UNITED STATES PATENT AND TRADEMARK OFFICE

10/550,086

| Office Action Summary | Application No. 10/550,086 | Applicant(s) DECOTTIGNIES ET AL. | |

DETAILED ACTION

Figure 1, as annotated by examiner

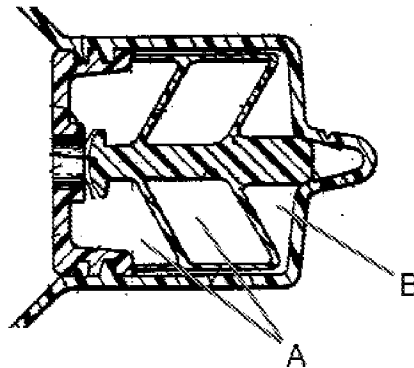
A dispenser according to claim 7 (see rejection of claim 7 above), in which the tube defines an internal volume (A, Figure 1 below as annotated by examiner) in which the inlet valve is received, the internal volume communicating with a peripheral volume (B, Figure 1 below as annotated by examiner) that extends around the tube inside the sleeve via at least one through opening (inherently at least one opening for proper operation of device), the dispensing chamber including the internal volume and the external volume.
